SB, Steering linkage not according to specs, CRT 36 and CRT 48 Trowels, 2026-03

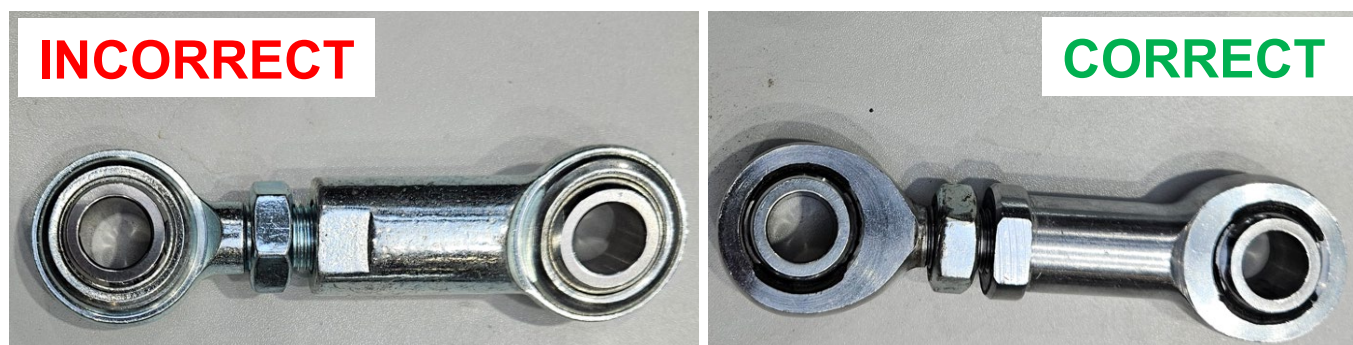
Some CRT 36 and CRT 48 trowels have been produced with steering linkages 599038401 that are not according to specs. This might cause them to snap.

Replace all the linkages 599038401 to secure normal operation of the machine.

Identify the correct part according to the pictures below.

Scrap all the incorrect parts in the local stock.
